155-056-10

## **ADDENDUM NO. 1**

Nebraska Administrative Services - 1526 Building Remodel  
Lincoln, NE  
TCEP Project No.: 156-056-10

Addendum #01  
Supplemental Drawing: SDA-006  
Revision of Sheet: A0.4  
Date: March 23, 2012

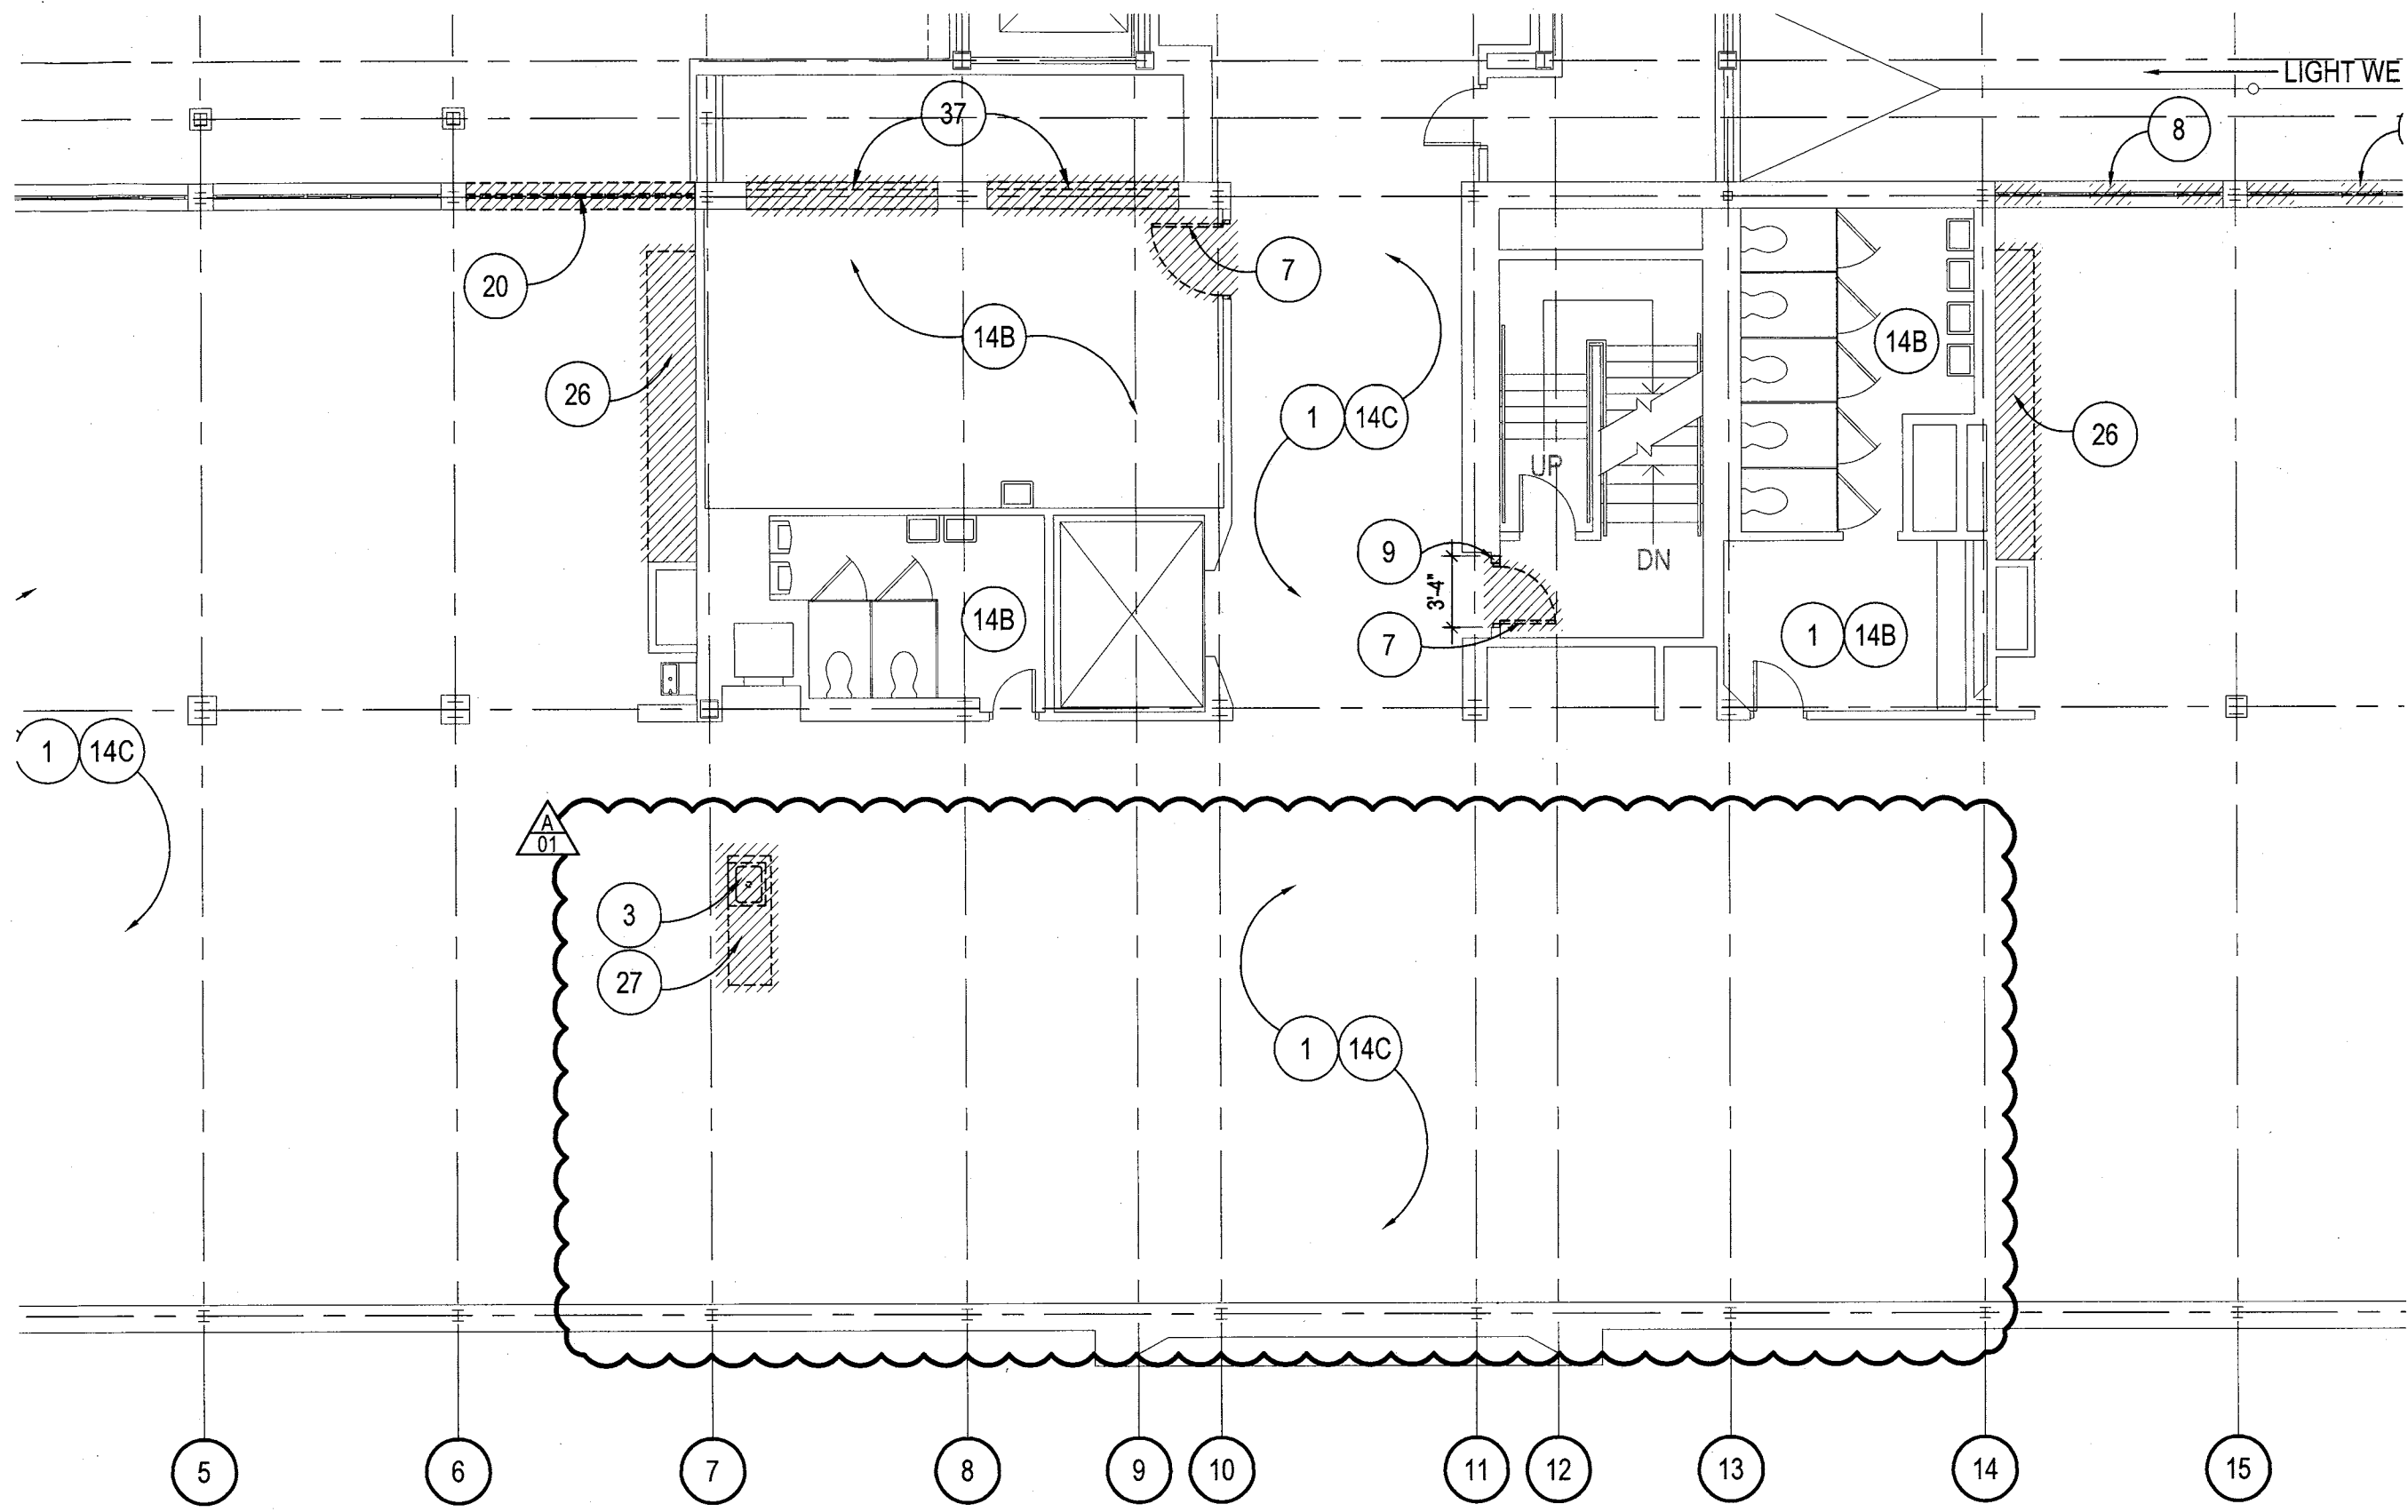
Refer to attached supplemental drawing SDA-006 for changes to drawing. Removed wall demolition from scope of demolition work.

Addendum #01  
 Supplemental Drawing: SDF-001  
 Revision of Sheet: F1.4  
 Date: March 23, 2012

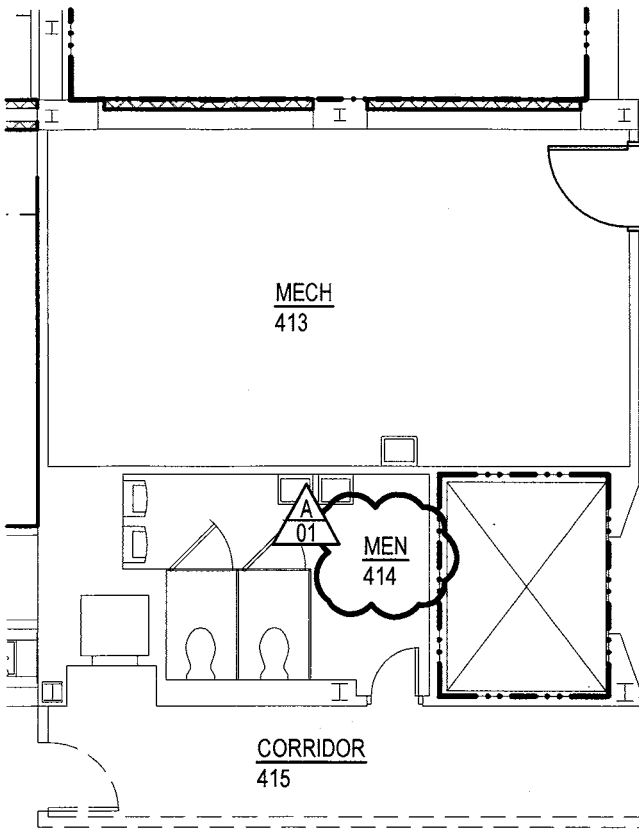
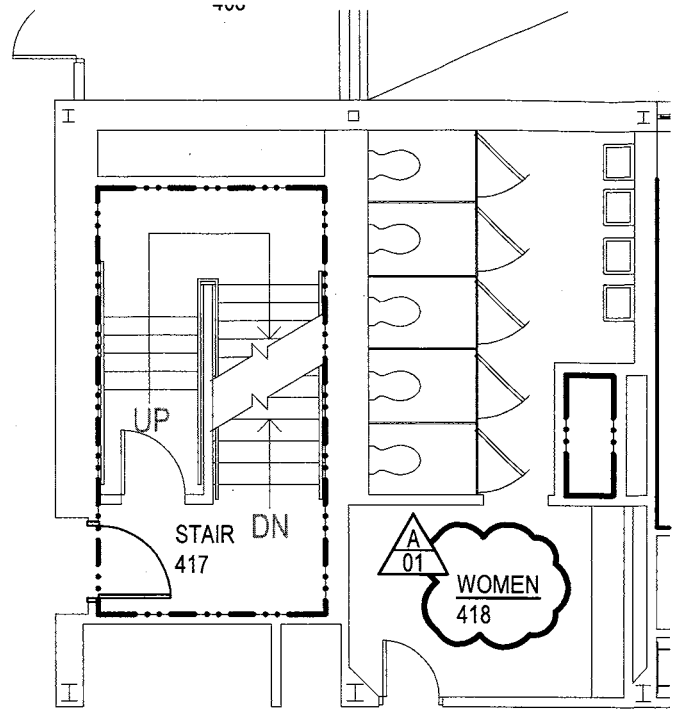
Refer to attached supplemental drawing SDF-001 for changes to drawing. Changed room names.

Addendum #01  
 Supplemental Drawing: SDF-002  
 Revision of Sheet: F1.4  
 Date: March 23, 2012

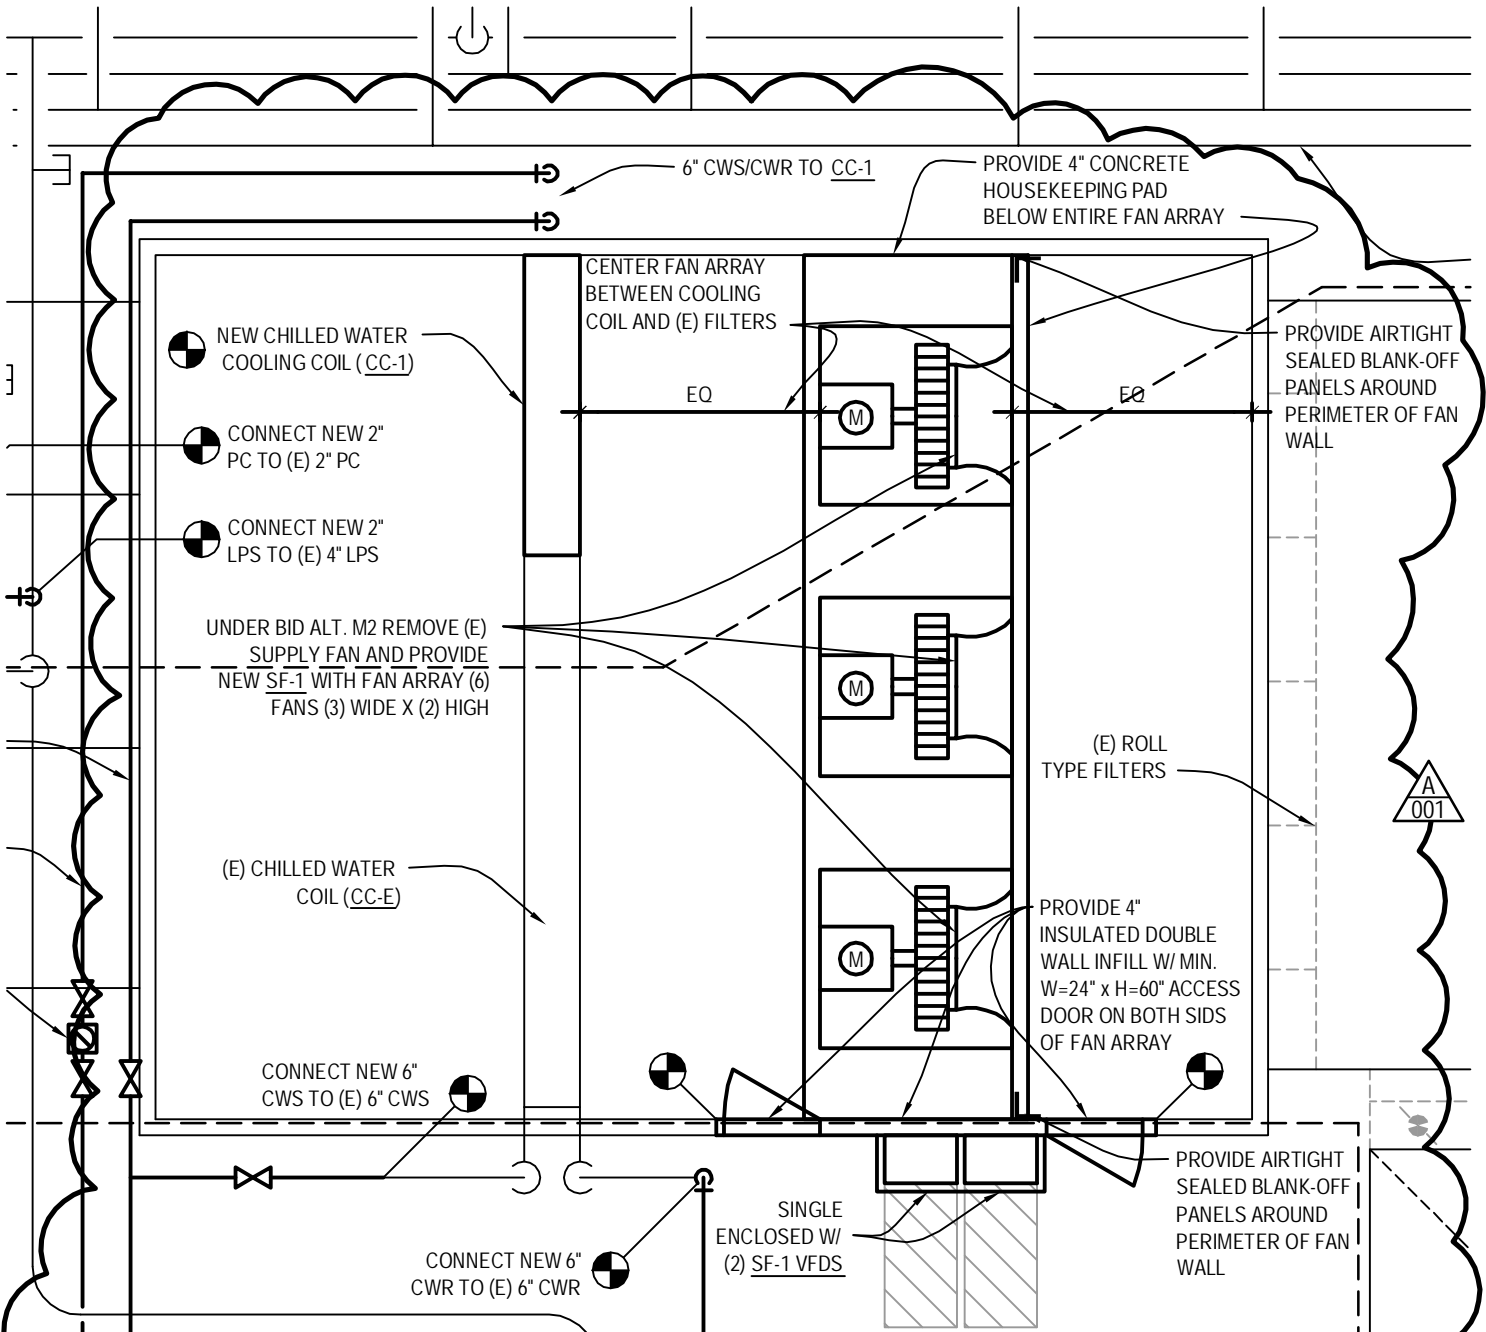
Refer to attached supplemental drawing SDF-002 for changes to Finish Schedule. Changed room names. Changed Note #5.

Addendum #01  
 Supplemental Drawing: SDM-002  
 Revision of Sheet: M3.1  
 Date: March 23, 2012

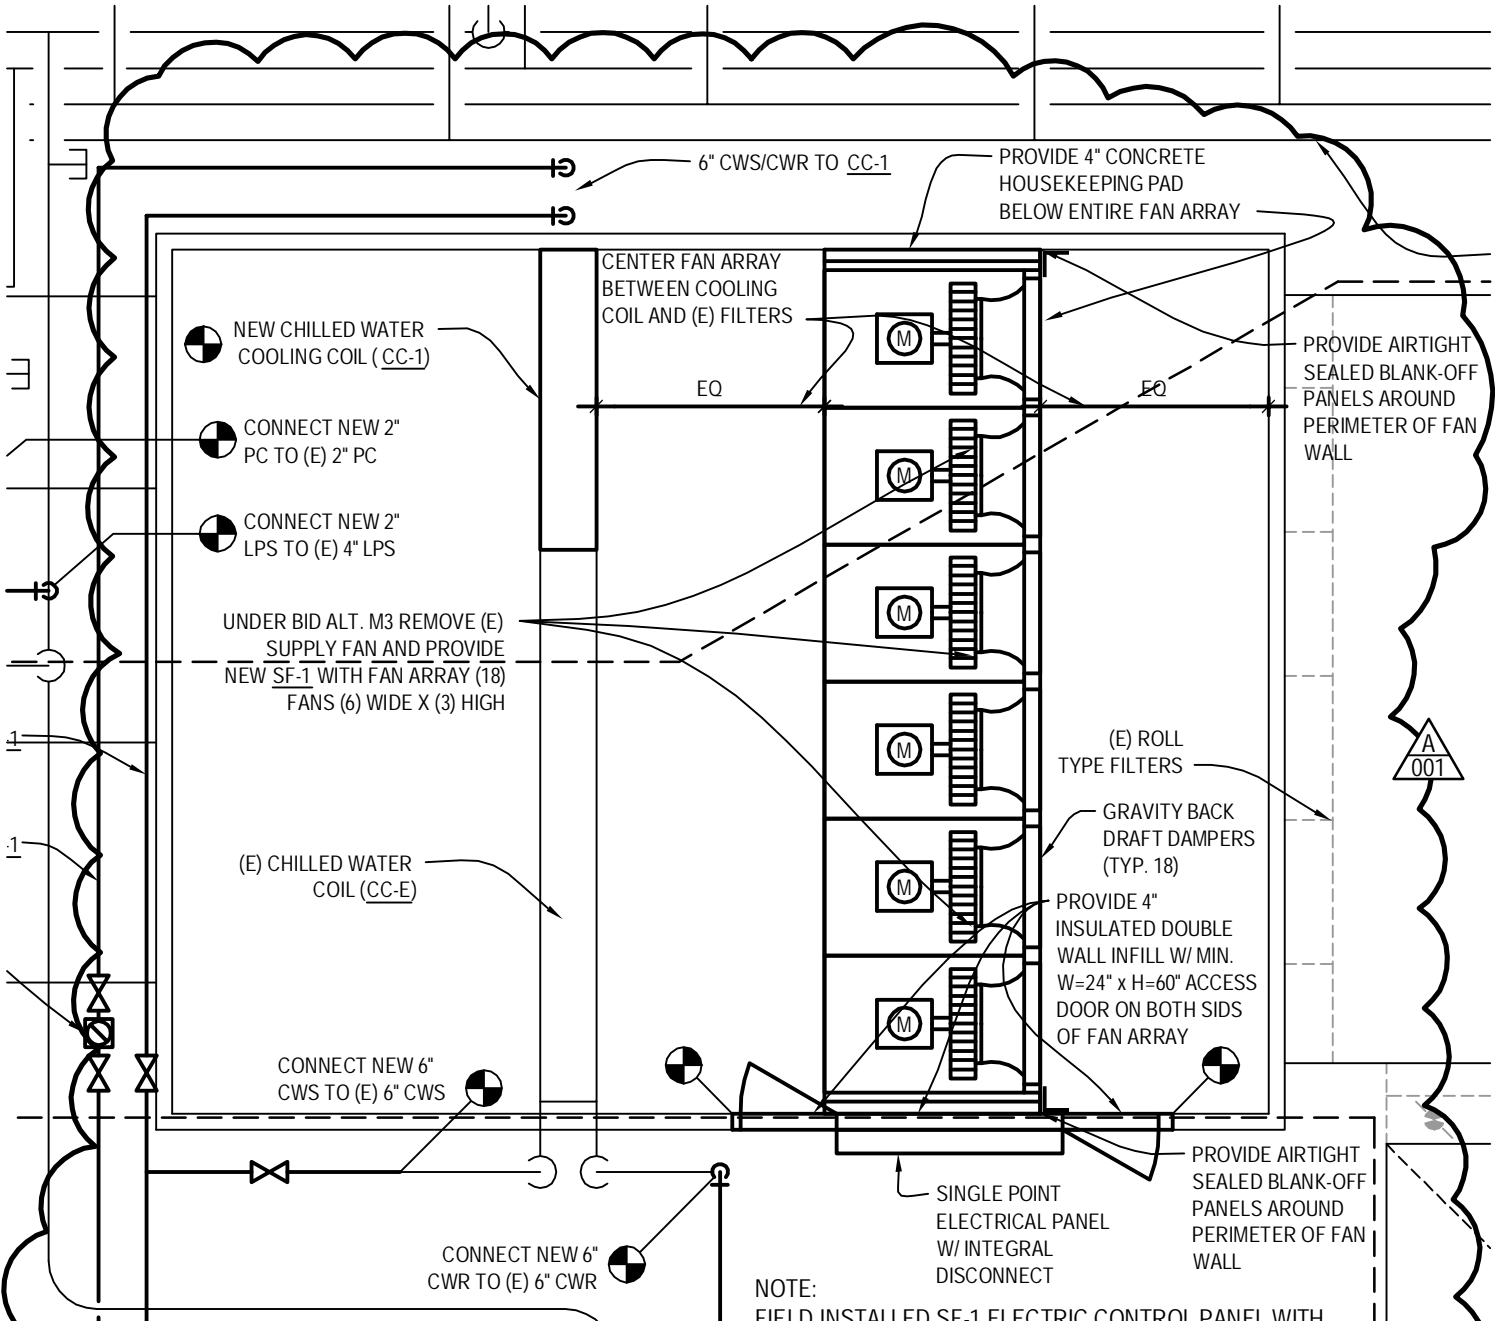
- Under Bid Alternate M-2 provide a new six (6) fan wall as shown on the attached Partial Enlarged Basement Mechanical Room Plans, Supplemental Drawing SDM-002. With this Alternate M-2, the new SF-1 to be a 3 wide x 2 high direct drive fan matrix, Climate Craft model 27MTX or equivalent with each of the six (6) 27” diameter fans capacity to be 20,000 CFM at 6” WC TSP, 28.59 BHP, 2158 RPM, premium efficiency inverter duty rated 30 HP, 208 volt, 3 phase, 60 HZ motor. The total fan matrix capacity to be 120,000 CFM at 6” WC TSP and total electrical characteristics are FLA= 496 amps, MCA = 558 amps, MOCP=800 amps. Provide with three manually installed fan blank-off plate to be installed to prevent back flow through the off fans, if one VFD or fan(s) becomes disabled. The fan wall to be provided with a electrical cabinet with (2) 100 HP VFD’s serving 3 fans each, integral electrical single point non-fused disconnect, VFD service switches, VFD input fuses and motor overload protection and associated equipment. This 6 fan matrix’s (2) 100 HP VFD’s to be controlled by the BMS, with all 6 fans operating in parallel as necessary to satisfy the 3<sup>rd</sup> and 4<sup>th</sup> floor SA duct main static pressure sensors.

NOTE:  
 BMS TO PROVIDE AND INSTALL SF-1 VFD AND CONTROL FAN WALL IN PARALLEL AS NECESSARY TO SATISFY SA DUCT STATIC PRESSURE SENSOR.
